# AGENDA

**The Columbia Architectural Design Review Team will meet on Tuesday, June 7th, 2022 at 8:00 a.m. in Conference Room A on the basement level of City Hall, 700 N. Garden Street to consider the following:**

**Sheet Name**  
**EXTERIOR ELEVATIONS**

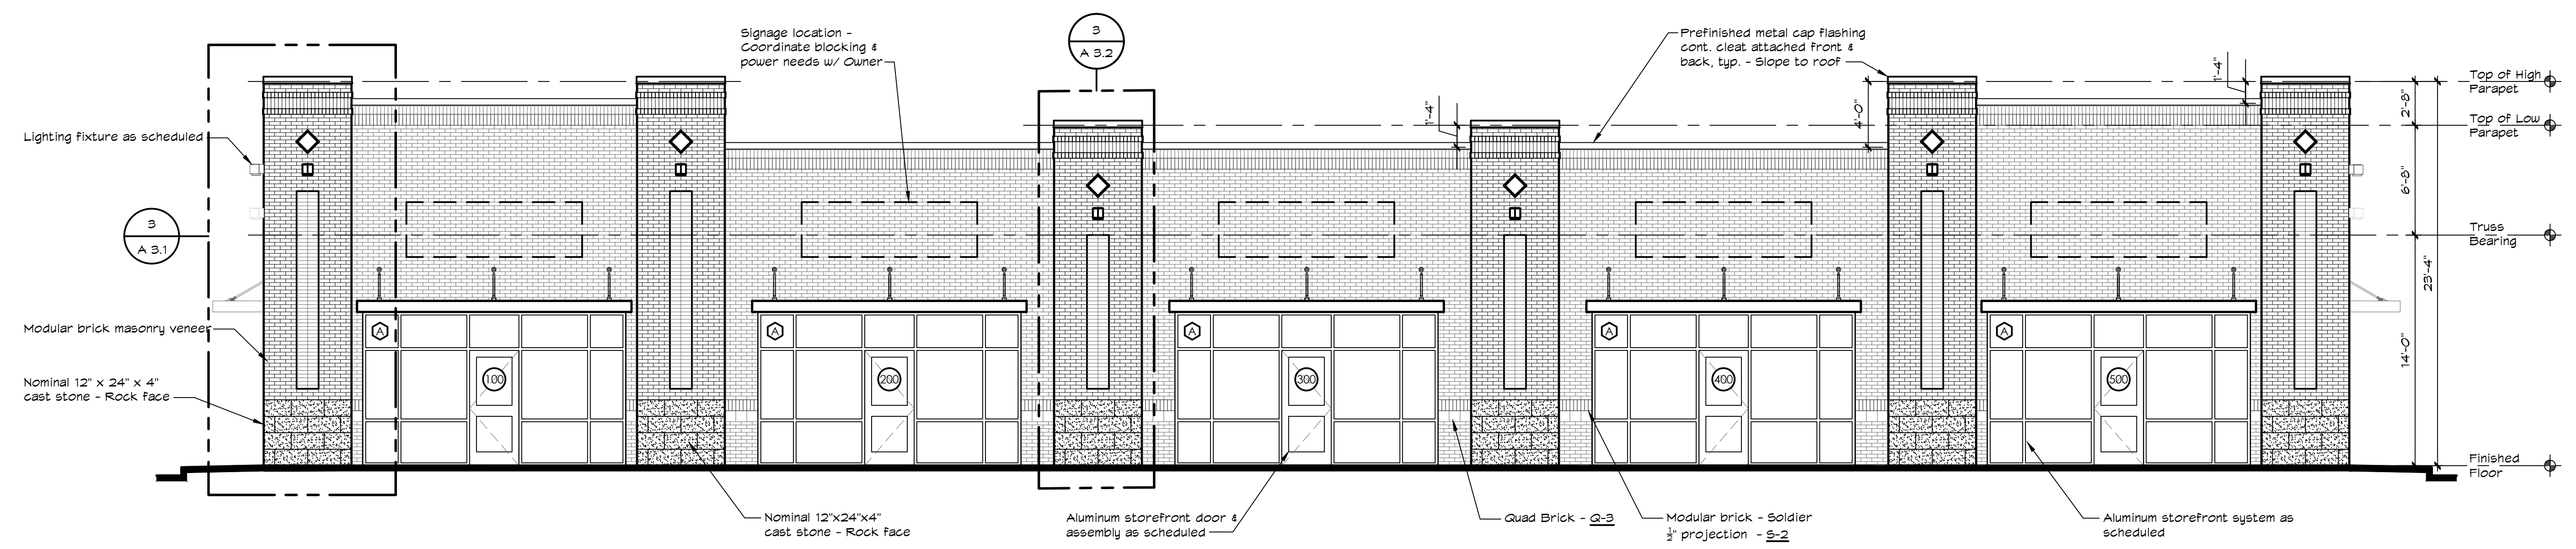
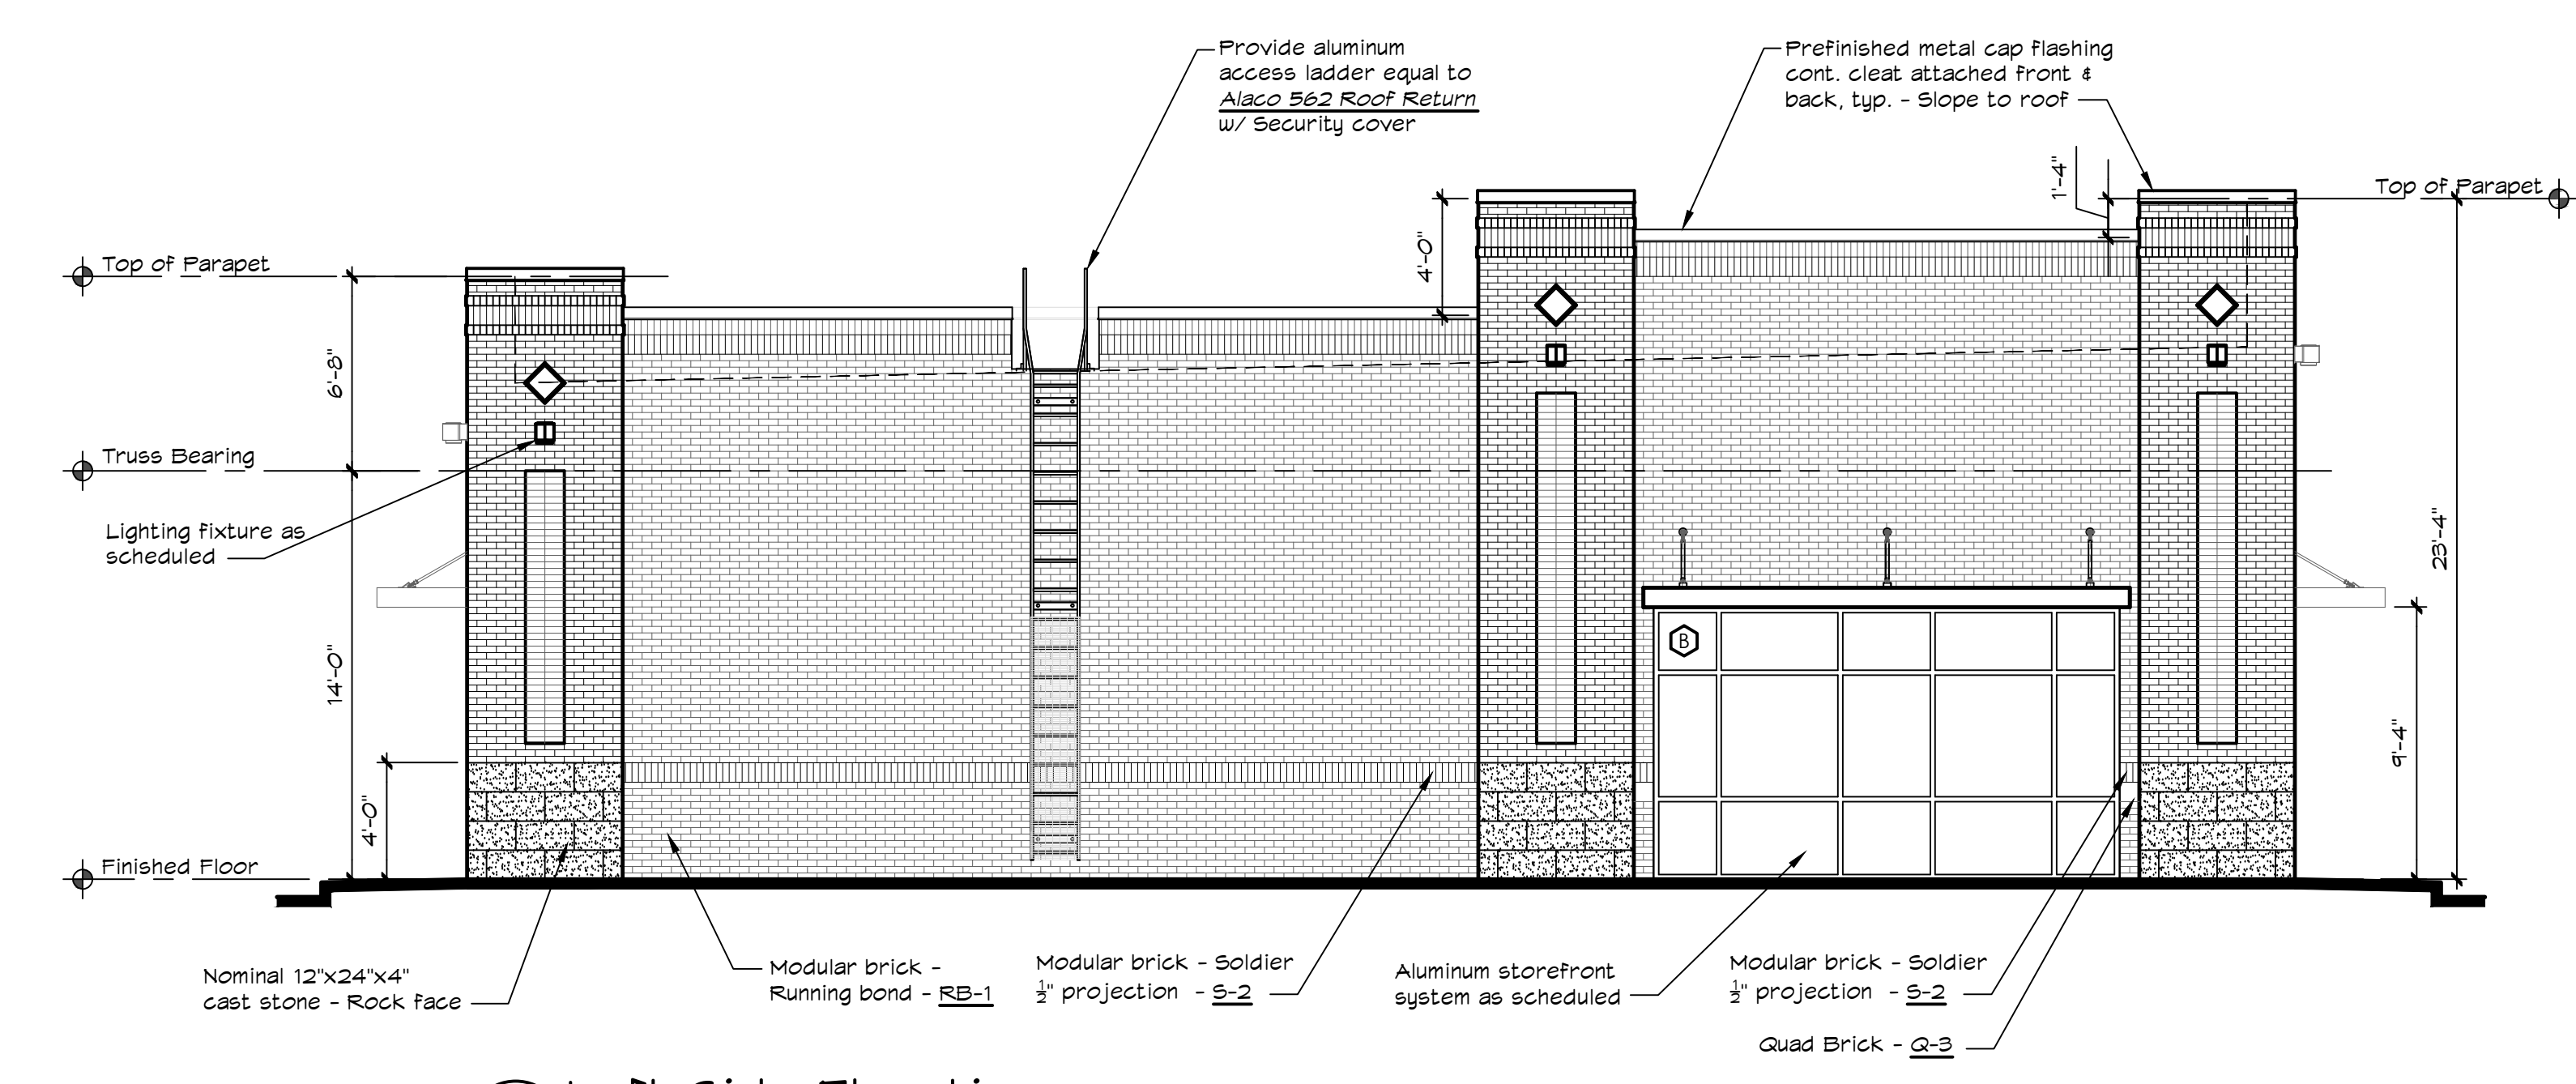
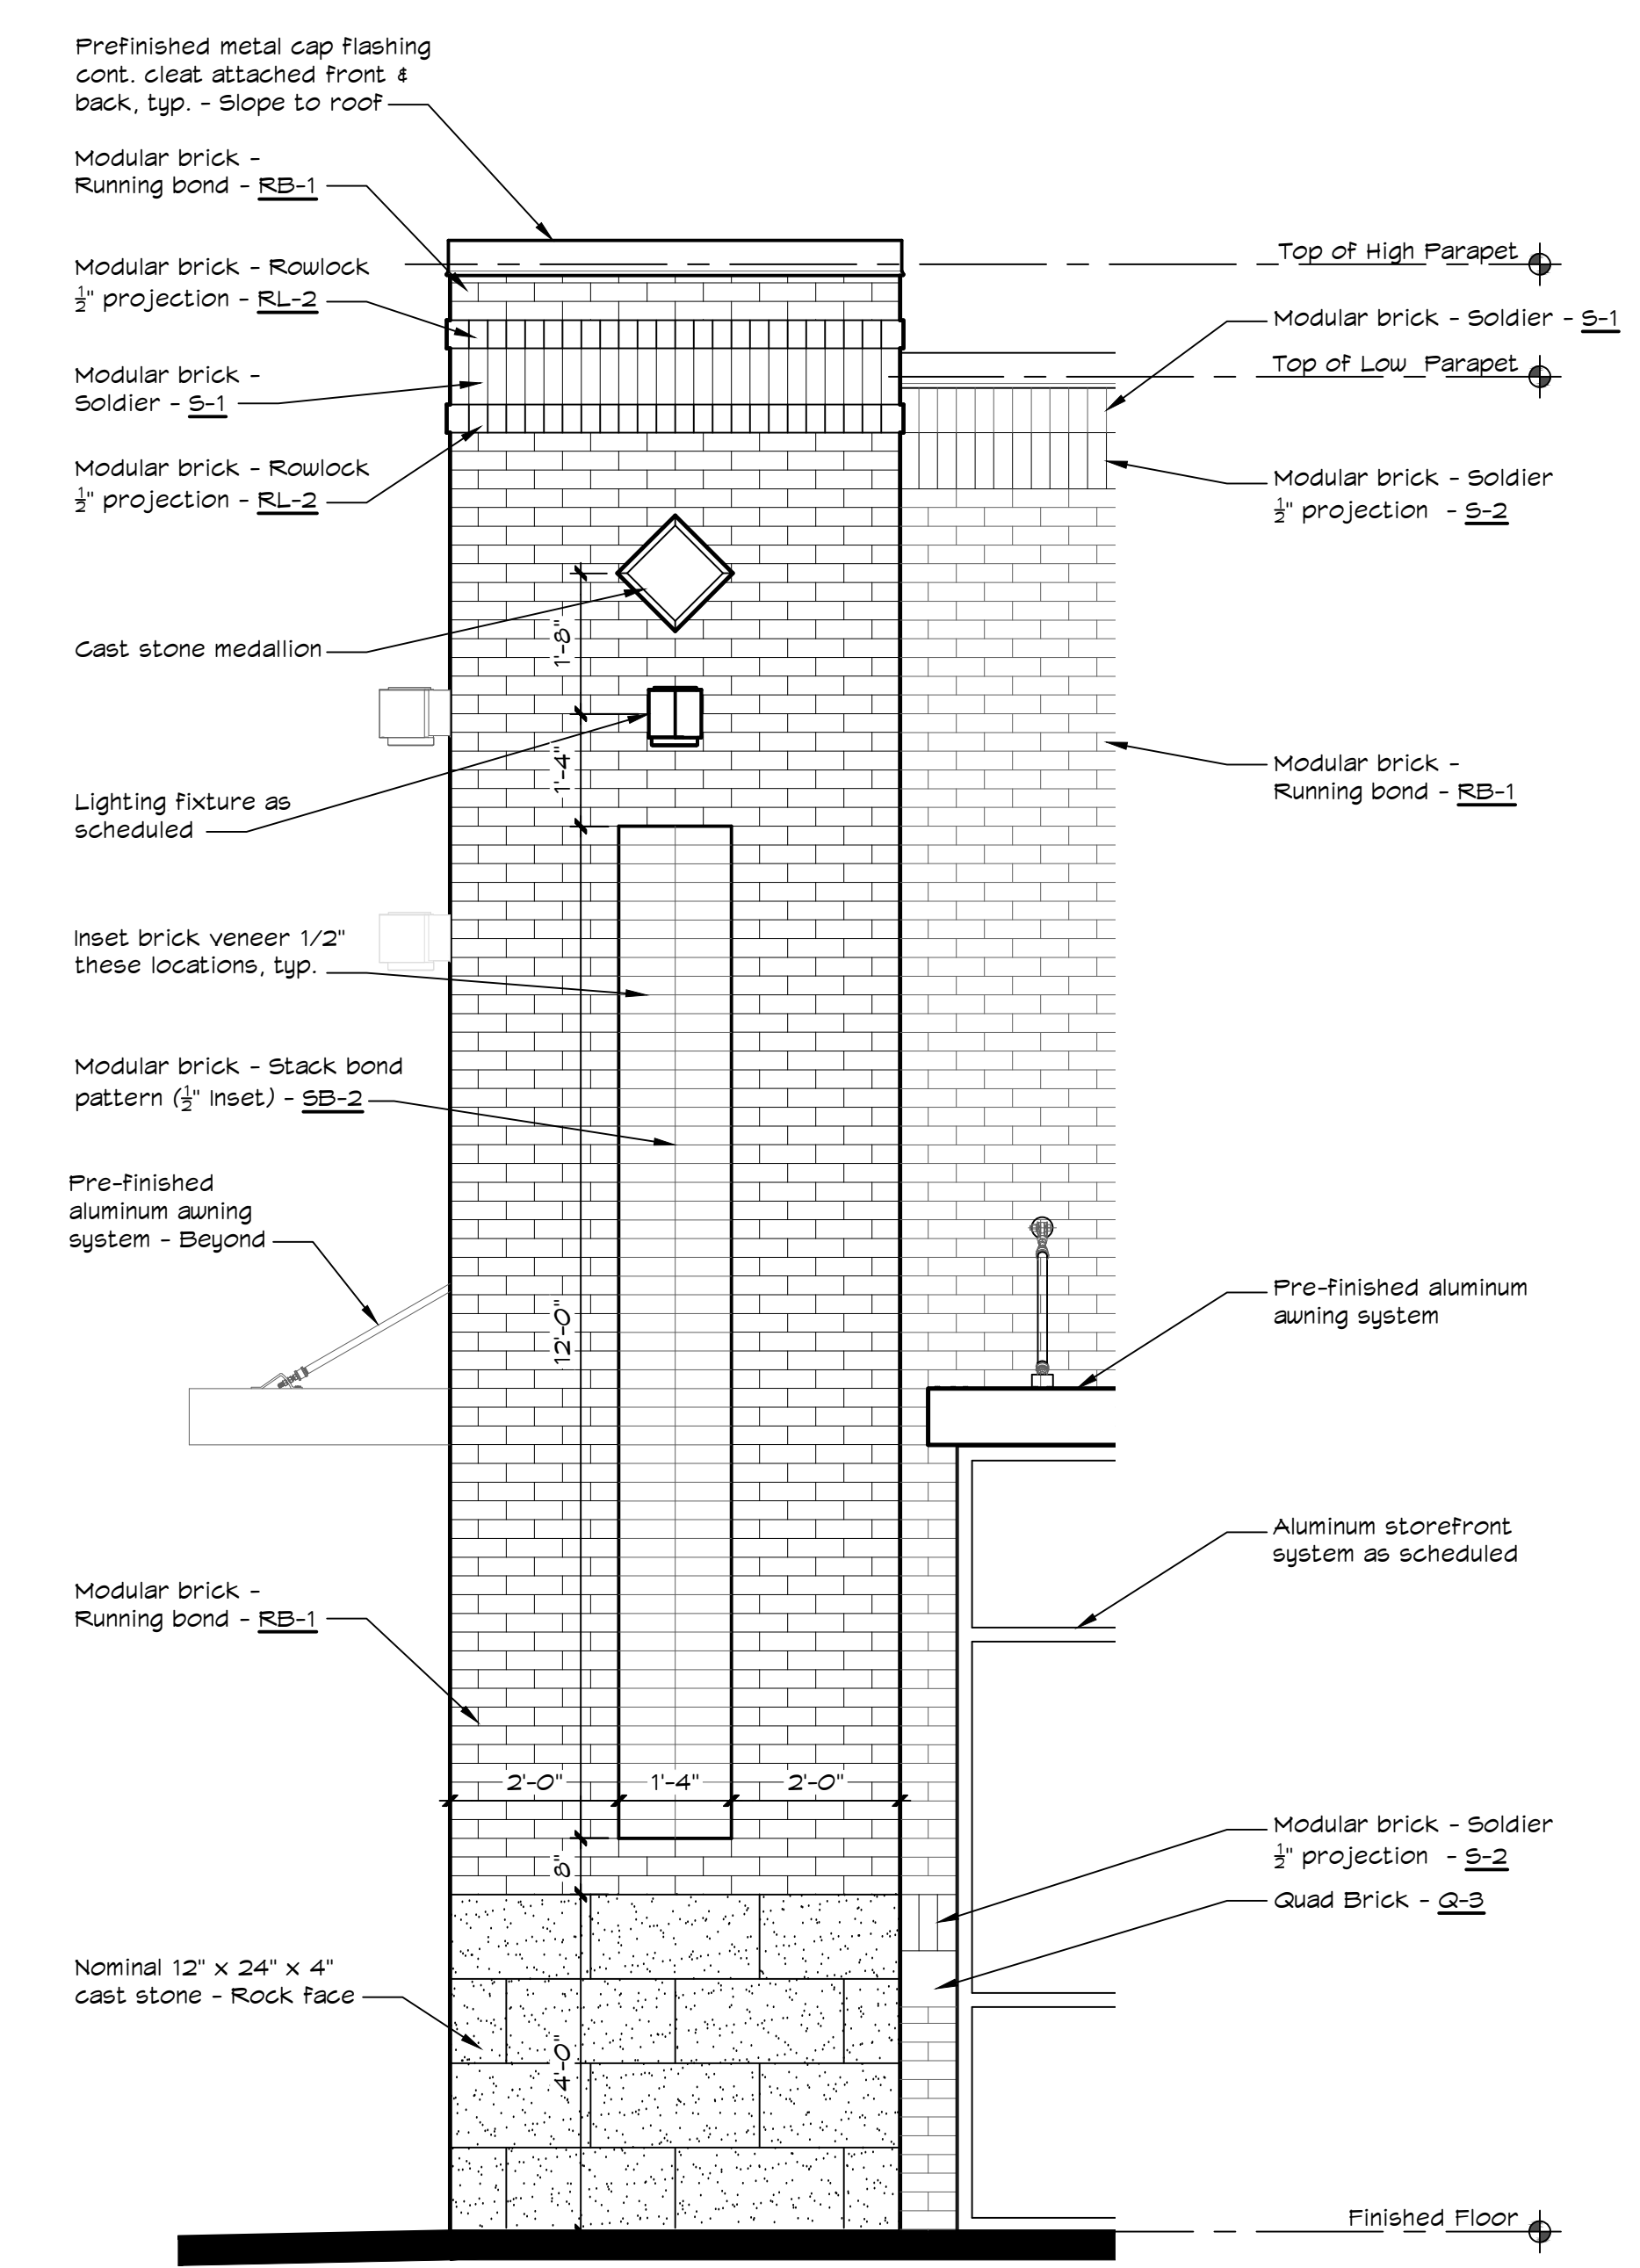
- The proposed west (rear) building elevation will consist of a primary façade material of brick accented by brick soldiering within the base and the columns. Each individual pilaster will be accented by a stone medallion detail. Aluminum storefront windows will be facing the Cayce Lane elevations. The front elevation will consist of the same primary façade materials as the rear elevation with a combination of brick details separated by brick pilasters.
- The right and left (side) elevations will consist of a primary brick material as all other elevations with a 4' recessed parapet.
- It shall be recommended that as a condition of approval that all rooftop HVAC equipment be screened by the raised parapet with no exterior visibility.
